SB Number:	SB PF-011	Creation Date: 17/11/2004
Subject:	Paper catches behind cursor ('SPACER PF F/R' added)	
Model:	PF-30A, PF-35

PF-35: Paper feeder for KM-C830/C830D and KM-C850/C850D
PF-30A: Paper feeder for KM-C830/C830D and KM-C850/C850D

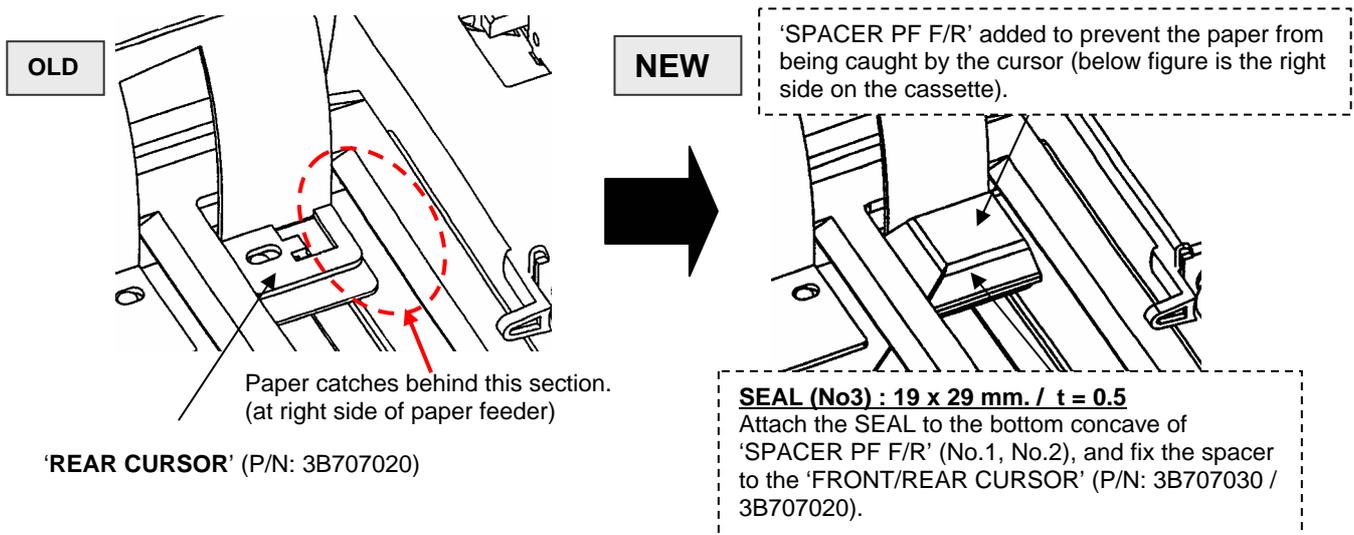
Please be informed that in order to prevent the newly set paper from being caught behind the cursor, the 'SPACER PF F' (No.1), 'SPACER PF R' (No.2) and 'SEAL SPACER PF35' (No.3) have been added.

Attach the 'SEAL SPACER PF-35' (No.3) to the bottom of the spacer and attach it to the front/rear cursor.
